EDMS NO. 3190374	REV. 0.1	VALIDITY DRAFT
----------------------------	--------------------	--------------------------

REFERENCE LHC-XRP-EC-0021

ENGINEERING CHANGE REQUEST

Rotation of PPS Roman Pots to Adapt to Vertical Beam Crossing in IP5

Figure 1: The horizontal XRP stations that will be rotated in the sectors 4-5 and 5-6 are indicated by yellow arrows.

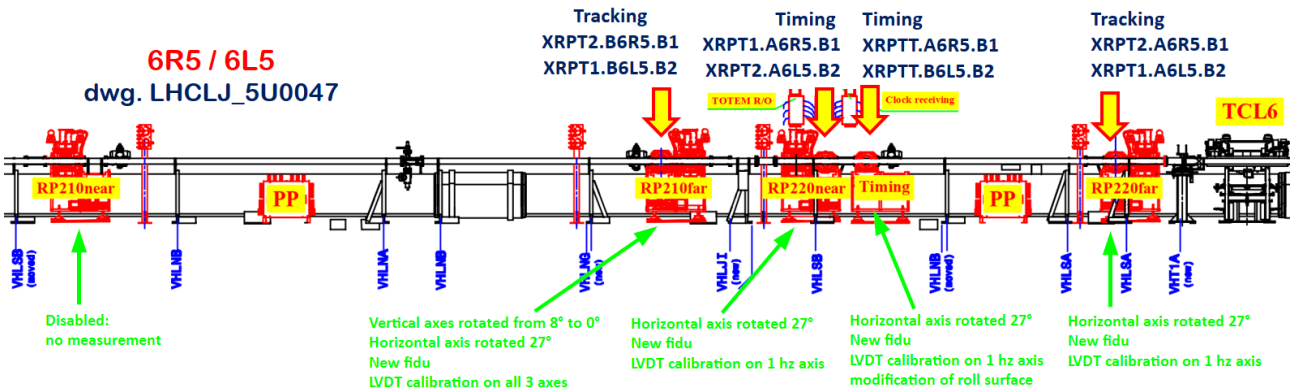
To restore the acceptance needed to reach the physics goals of PPS with the changed collision plane at IP5, a mechanical rotation of the horizontal RP horizontal stations by 27° clockwise with respect to the axis of the beam tube (looking from IP5 towards the XRP) is required [2]. This activity needs to be performed during the EYETS 2024/2025 to restart the data taking with the optimized acceptance of the XRP detectors.

Figure 4: Horizontal XRP before and after rotation. The red wedge in the bottom picture was requested by BE-GM-ASG to turn the alignment target vertical.

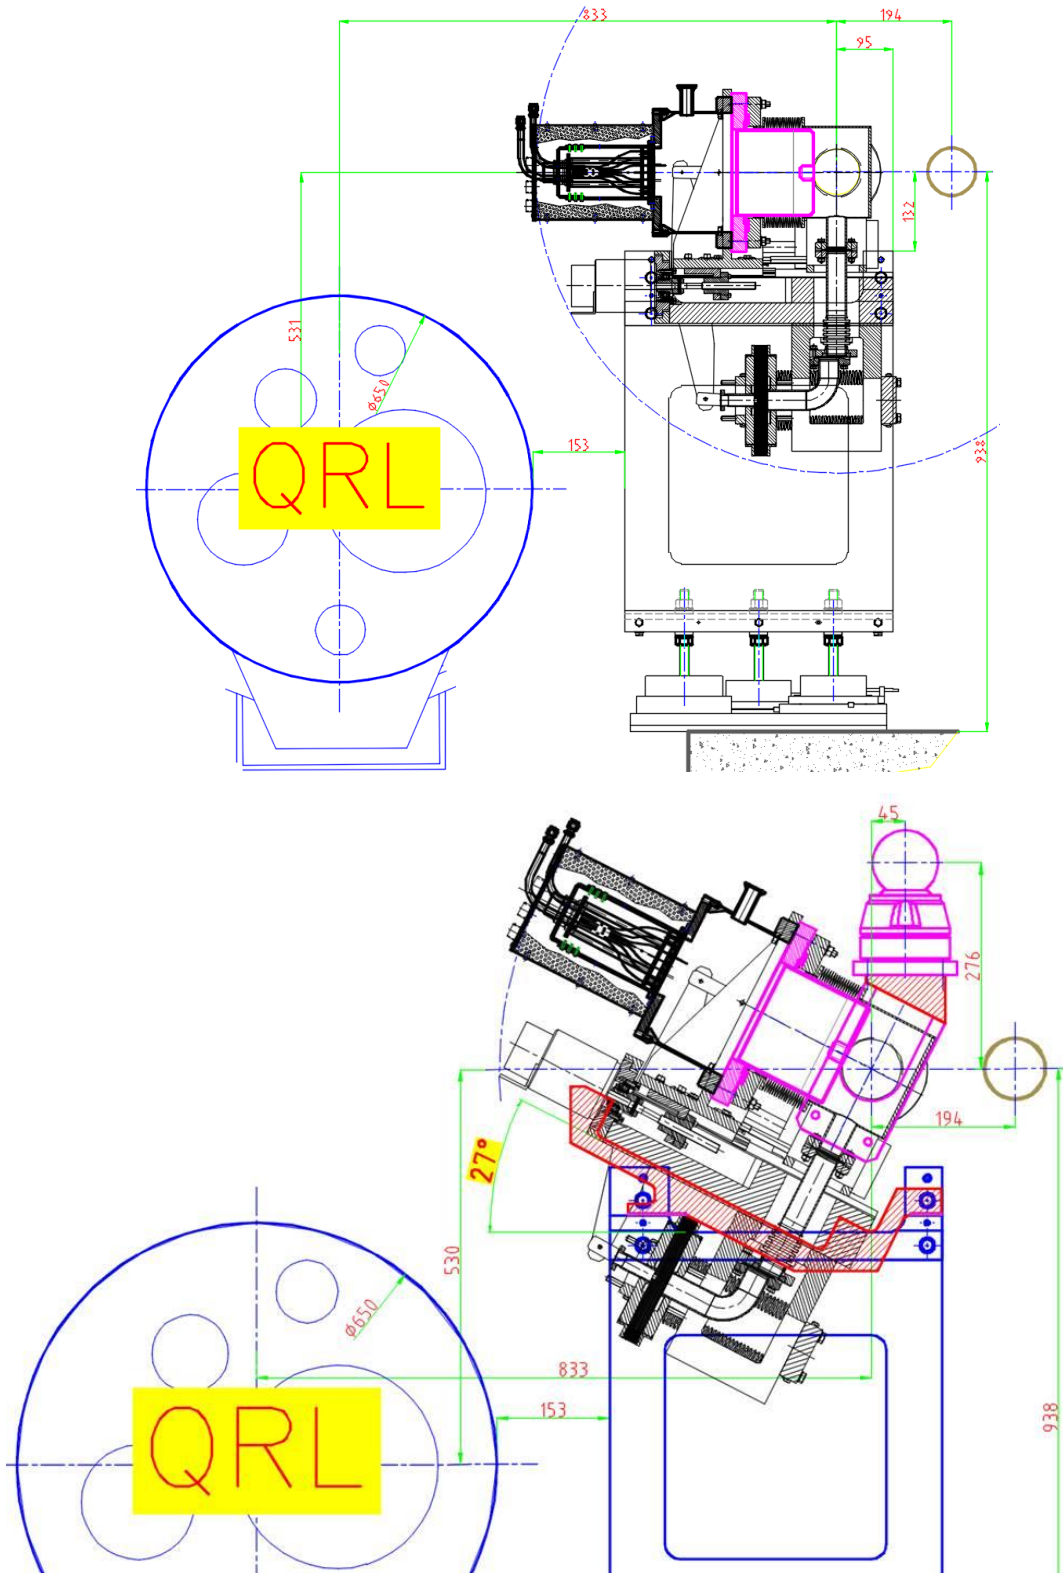
To perform the rotation (Figure 4, Figure 5), each horizontal XRP unit will be first disconnected from the beam tube by removing the connection bellows.

Figure 5: Top: sequence of operation for horizontal XRP rotation. Bottom: Mounting tool used in the LHC tunnel to lift the horizontal XRP.

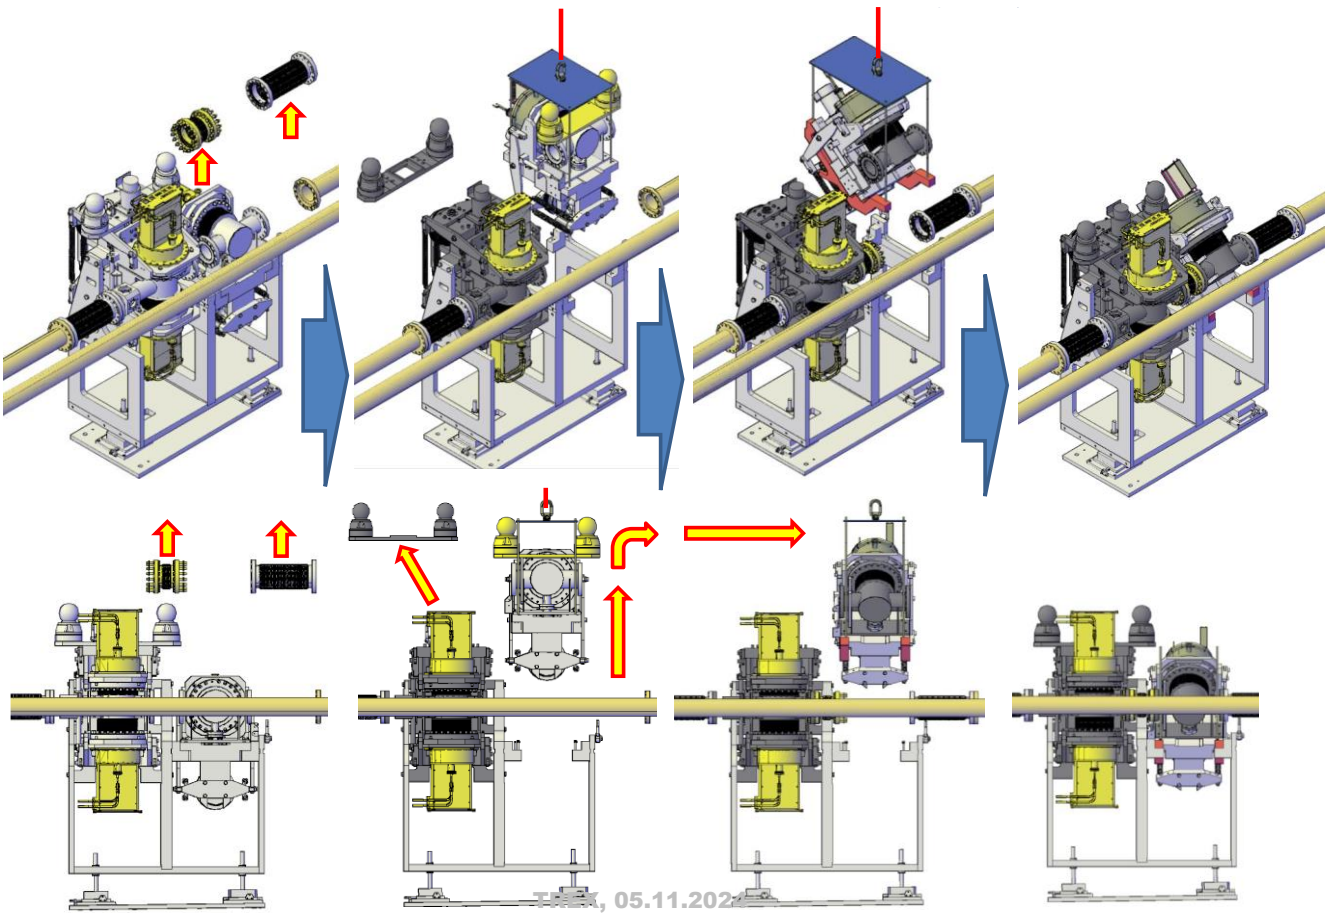
In the next step, the screws fixing the XRP unit to the base structure are loosened. With a special mounting tool (Figure 5, bottom), the individual XRP unit (about 70 kg) will be lifted from the base structure by about 40 cm, and the fixation brackets are dismantled. After reinstallation of the new brackets defining the rotation angle, the XRP unit is lowered and reconnected to the base structure. After the rotation, the service cables of the motor drives are reconnected. To test the XRP movement with the motor under the new rotation angle, the XRP vessel is driven in and out for about 1000 cycles. At the end of the movement cycle, the XRP is extracted with the spring.

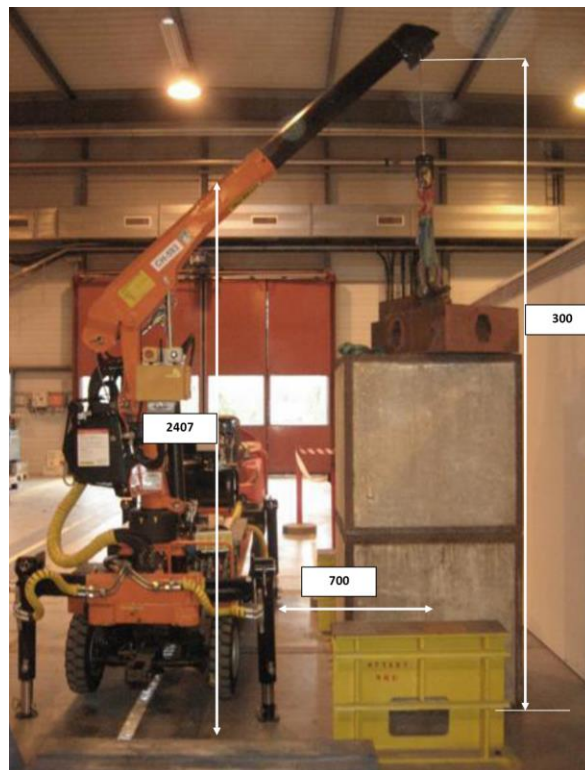
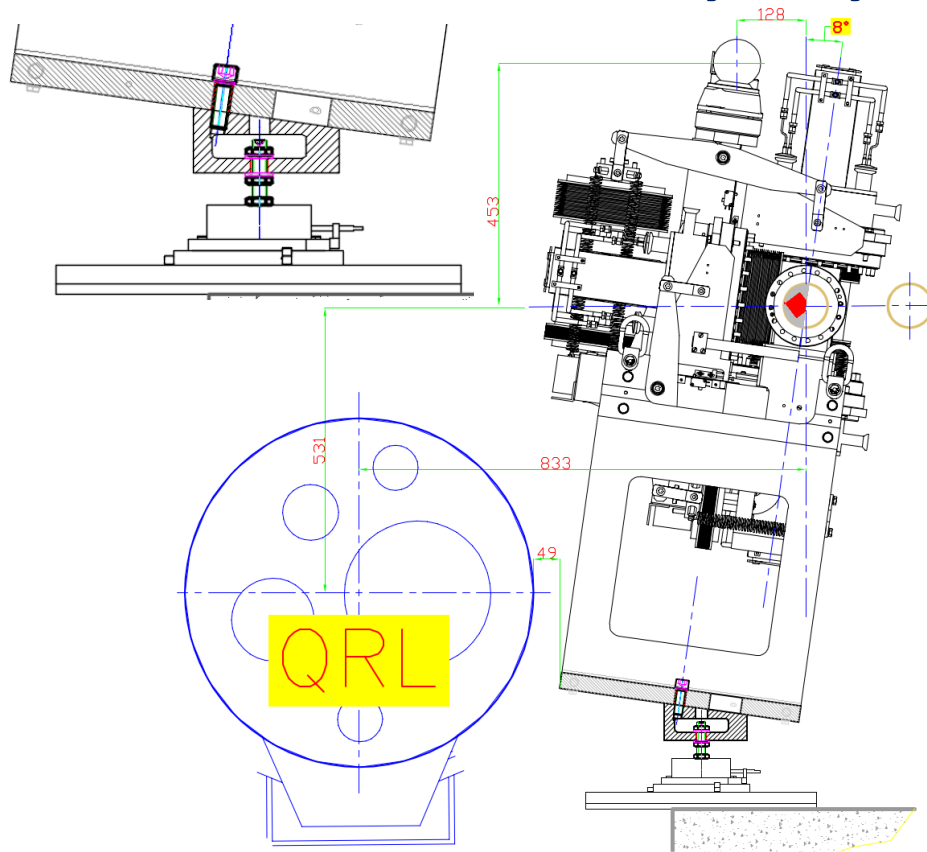
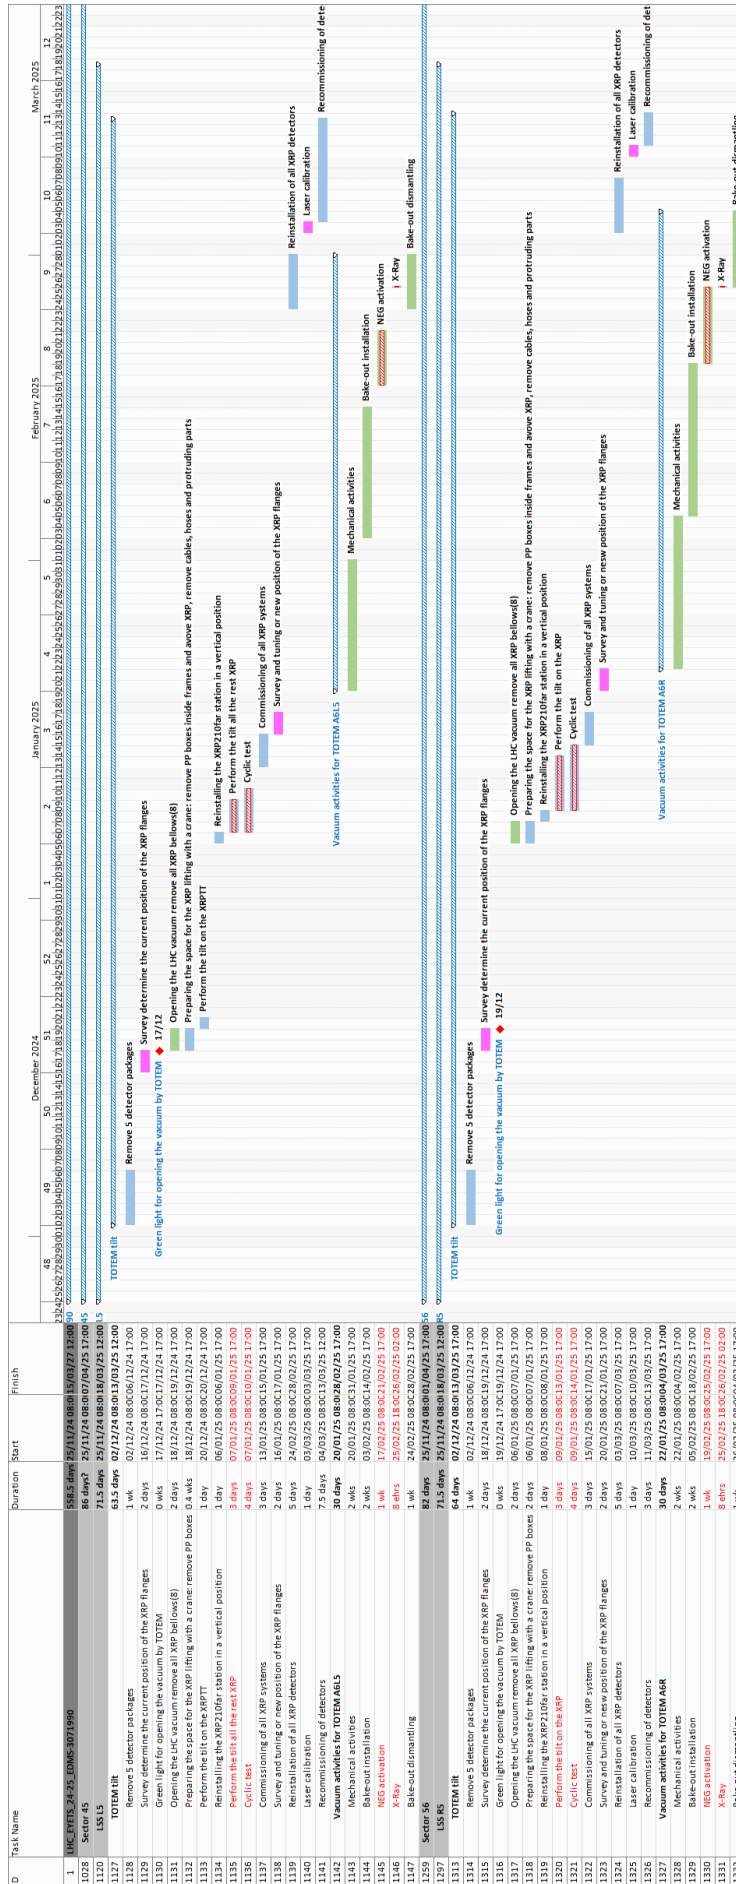
The units XRP-45-210-F and XRP-56-210-F units (150 kg weight for these triple units, horizontal pot + vertical pair) were already rotated by 8° during LS1 (Figure 6, top). However, the rotation was mechanically performed by an inclination of the base structure with special brackets. This unit needs to be rotated back to 0° by removing these brackets, prior to the axial rotation with the new 27° brackets. This procedure requires a special lifting tool (Palfinger). The entire unit with a weight of about 150 kg will be lifted about 50 cm with the Palfinger via a carrying structure (Figure 6, bottom).
